**STAFF REPORT**

SUBJECT: WaFed – CUP  
[H-2023-0068](#)

LOCATION: 3423 E. Ustick Rd. in the NW 1/4 of Section 4, T.3N., R.1E. (Lot 10, Block 1, Southeast Corner Marketplace Subdivision No. 2)

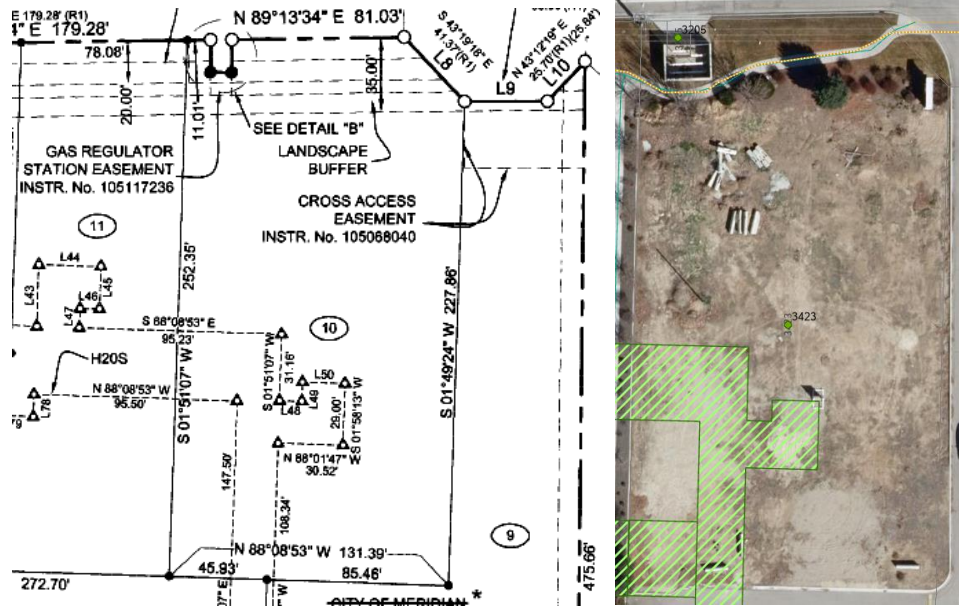
- C. Landscape shrubbery shall be limited to no more than three (3) feet in height between entrances and financial transaction areas and the public street. ***The Appliance should comply with this standard; modifications to the existing street buffer landscaping along Ustick Rd. may be necessary.***

**Landscaping:** Street buffer landscaping was installed within the street buffer along E. Ustick Rd. with the subdivision improvements as shown below:

- f. Landscape shrubbery shall be limited to no more than three (3) feet in height between entrances and financial transaction areas and the public street as set forth in UDC [11-3A-16C](#); modifications to the landscaping in the existing street buffer along Ustick Rd. may be necessary.

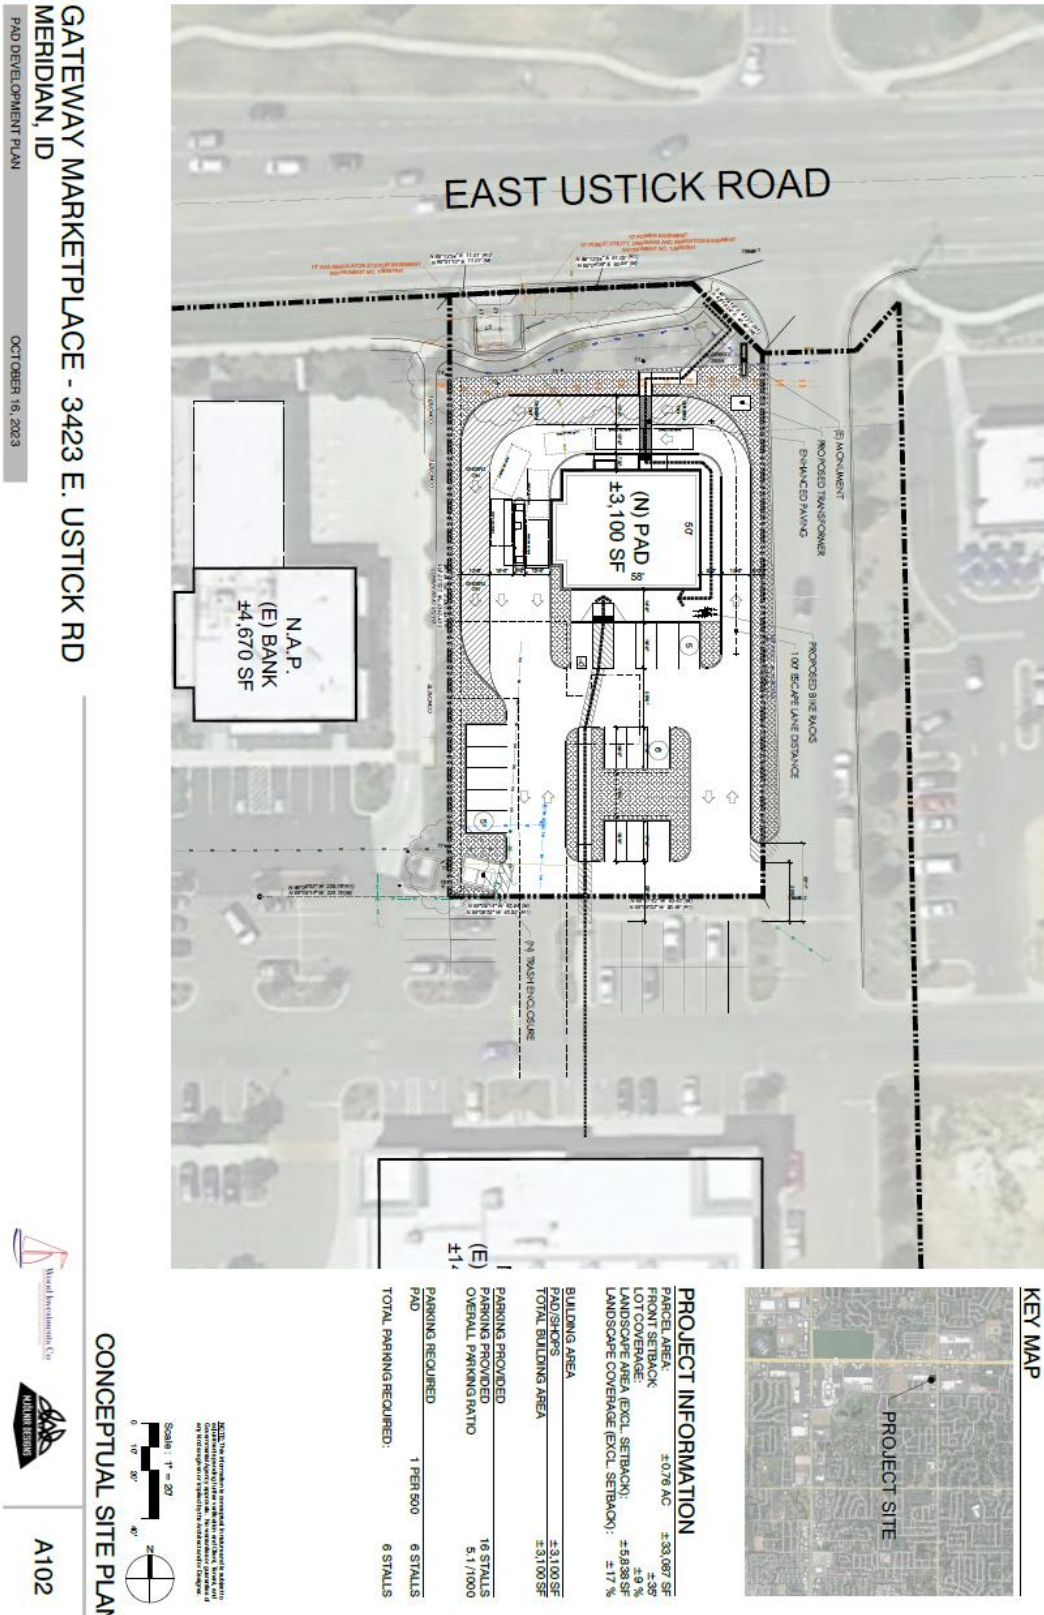
**Easements:** There are existing easements on this lot as shown on the Southeast Corner Marketplace Subdivision No. 2 plat, included below; **these easements should be depicted on the site plan to demonstrate the building doesn't encroach within the easements.**

- e. Depict the existing easements on this lot as shown on the Southeast Corner Marketplace Subdivision No. 2 plat – no structures shall encroach in any existing easements; relocate the trash enclosure accordingly.

## A. Proposed Site Plan (dated: 10/16/23)

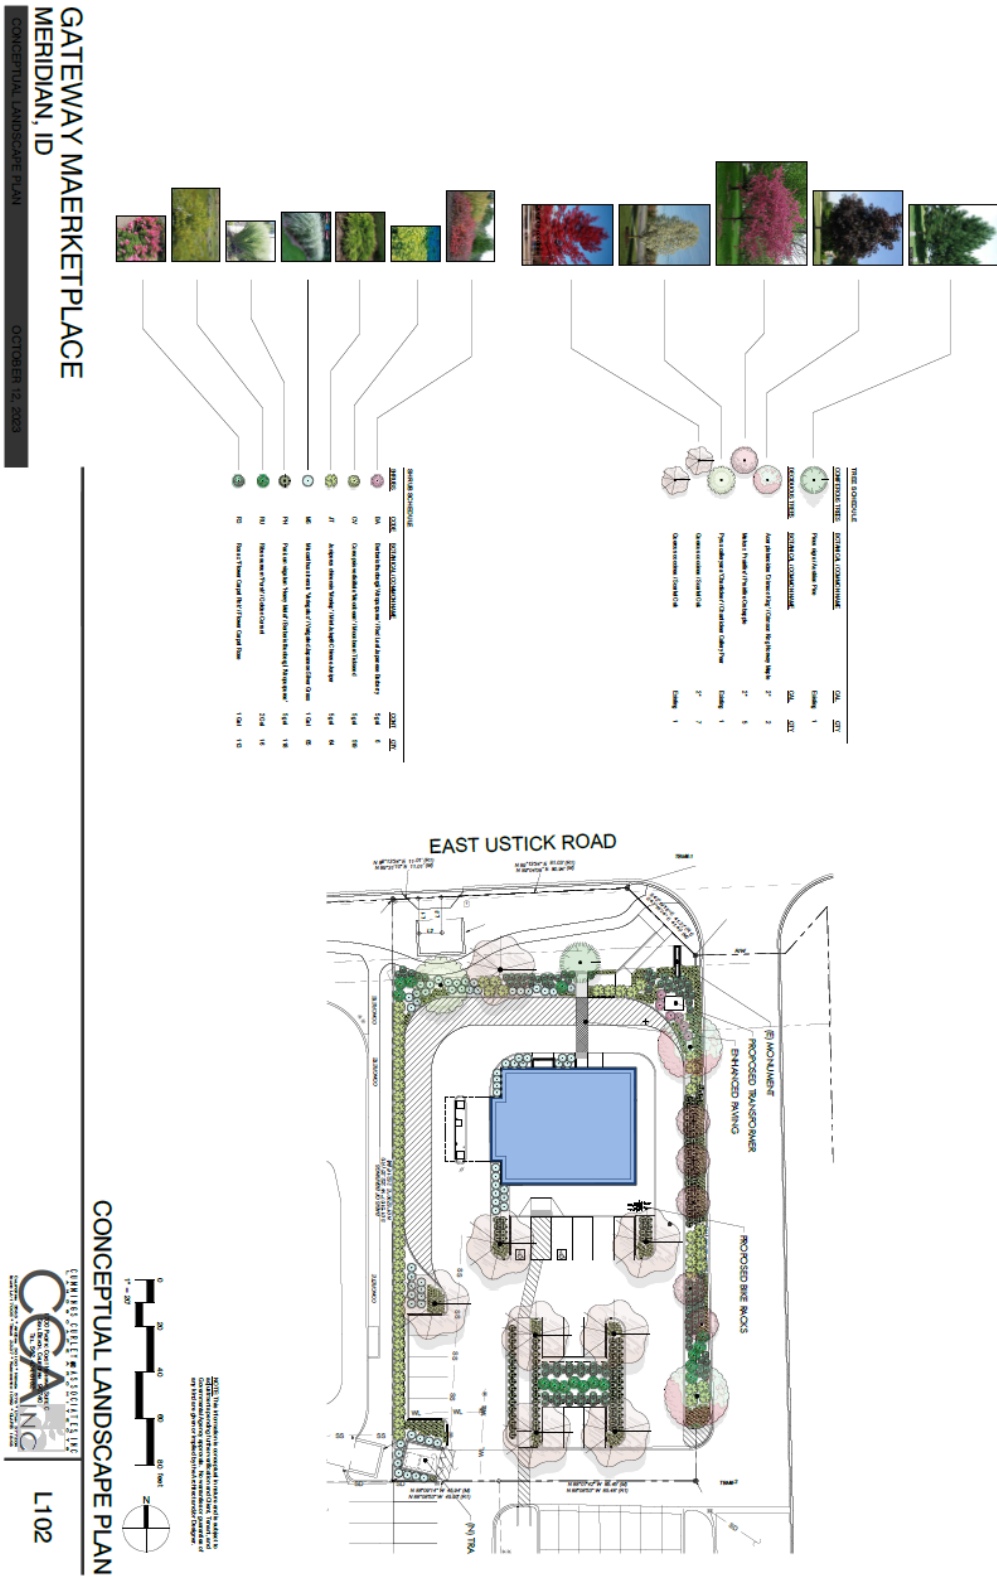
- **Drive-Through Establishment:** The proposed drive-through establishment is subject to the specific use standards listed in UDC [11-4-3-11](#), Drive-Through Establishment. All establishments providing drive-through service are required to identify the stacking lane, menu and speaker location (if applicable), and window location on the site plan. *The proposed site plan depicts the stacking lane and service locations.*

The site plan is required to demonstrate safe pedestrian and vehicular access and circulation on the site and between adjacent properties. *Pedestrian walkways are depicted on the site plan that should provide safe pedestrian connectivity to the south and to the north to the sidewalk along Ustick Rd. Vehicular access and circulation is provided on this site and with adjacent properties that should be safe.*

*An escape lane is depicted on the site plan.*

*The drive-through is located on the west side of the building and is visible from E. Ustick Rd.*

A bicycle rack capable of holding at least one (1) bicycle is required per UDC [11-3C-6G](#); bicycle parking facilities are required to comply with the location and design standards listed in UDC [11-3C-5C](#). A bike rack is depicted on the site plan; **a detail should be included on the site plan submitted with the Certificate of Zoning Compliance application that complies with the aforementioned design standards.**

**Sidewalks:** A detached sidewalk exists along the northern perimeter boundary of the site within the street buffer along E. Ustick Rd. A 5-foot wide pedestrian walkway is proposed from the perimeter sidewalk to the main building entrance in accord with UDC [11-3A-19.B.4](#). **The walkway is required to be distinguished from the vehicular driving surface through the use of pavers, colored or scored concrete, or bricks; the site plan should be revised accordingly.**

**Trash Enclosure:** The proposed location for the trash enclosure is within a City water/sewer easement; therefore, relocation of the enclosure is necessary outside of any and all easements. A receptacle for recycling should be provided within the trash enclosure; a detail should be submitted that demonstrates compliance.

- b. The pedestrian walkway from the perimeter sidewalk along E. Ustick Rd. to the main building entrance shall be distinguished from the vehicular driving surface through the use of pavers, colored or scored concrete, or bricks as set forth in UDC 11-3A-19B.4b.

- c. Include the tree classification in the Tree Schedule that demonstrates compliance with the standards in UDC [11-3B-8C.1b](#).
  - d. Include a detail for the bicycle rack that complies with the design standards listed in UDC [11-3C-5C](#).

- g. The perimeter buffer along the west boundary of the site in the area adjacent to parking shall be widened to a minimum of 7 feet to allow for vehicle overhang in accord with UDC [11-3C-5B.4](#) unless wheel stops are provided (if wheel stops are provided, the length of the parking spaces shall be 19 feet).

- h. Shift the walkway in the southern parking area in the planter island to the east side of the island with all of the landscaping on the west side of the walkway to prevent “cut-throughs” by pedestrians through the landscape area to the walkway.

B. Proposed Landscape Plan (dated: 10/12/23)

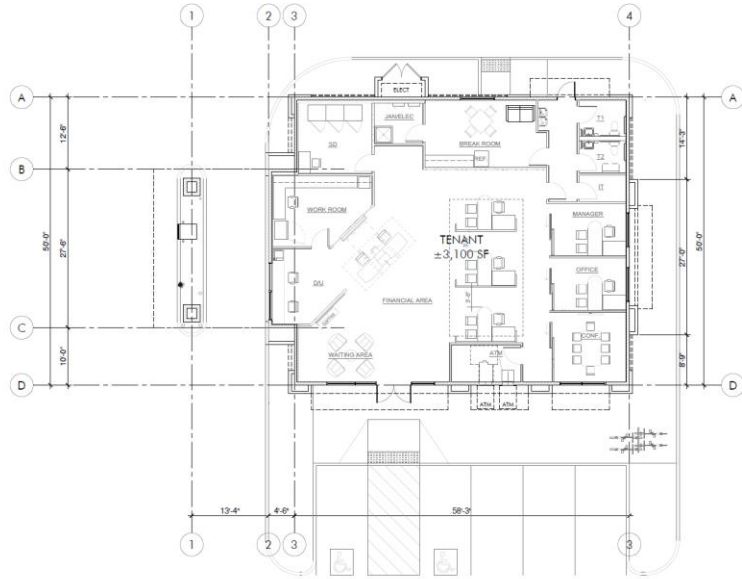
Parking lot landscaping is required to be provided in accord with the standards listed in UDC [11-3B-8C](#), except for the perimeter buffer along the west boundary. Because there is an existing buffer with trees that meet UDC standards on the adjacent property to the west, no trees are required within the perimeter buffer on this site. **The tree classification should be included in the Tree Schedule on the landscape plan to ensure compliance with UDC 11-3B-8C.1b. The perimeter buffer along the west boundary of the site in the area adjacent to parking shall be widened to a minimum of 7 feet to allow for vehicle overhang in accord with UDC [11-3C-5B.4](#), unless wheel stops are provided (if wheel stops are provided, the length of the parking spaces must be 19 feet). Staff recommends the walkway in the southern parking area in the planter island is shifted to the east side of the island with all of the landscaping on the west side of the walkway to prevent “cut-throughs” by pedestrians through the landscape area to the walkway.**

C. Floor Plan & Building Elevations (dated: 10/16/23)

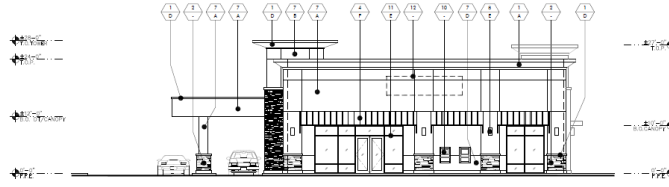
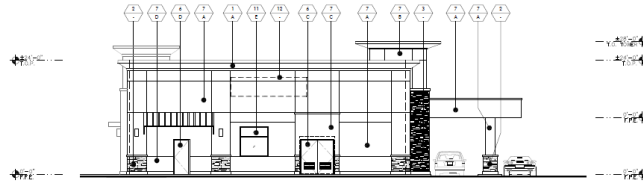
**Building Elevations:** Conceptual building elevations were submitted as shown in Section VIII.C for a single-story building that incorporates a mix of materials consisting of stucco with stone veneer accents and metal awnings and canopies. **The final design shall be consistent with the design standards listed in the [Architectural Standards Manual](#).**

6. A receptacle for recycling shall be provided within the trash enclosure; include a detail of the trash enclosure that demonstrates compliance.
7. A Certificate of Zoning Compliance and Design Review application shall be submitted and approved for the proposed use prior to submittal of a building permit application. The design

of the site and structure shall comply with the standards listed in UDC 11-3A-19 and the design standards listed in the Architectural Standards Manual.
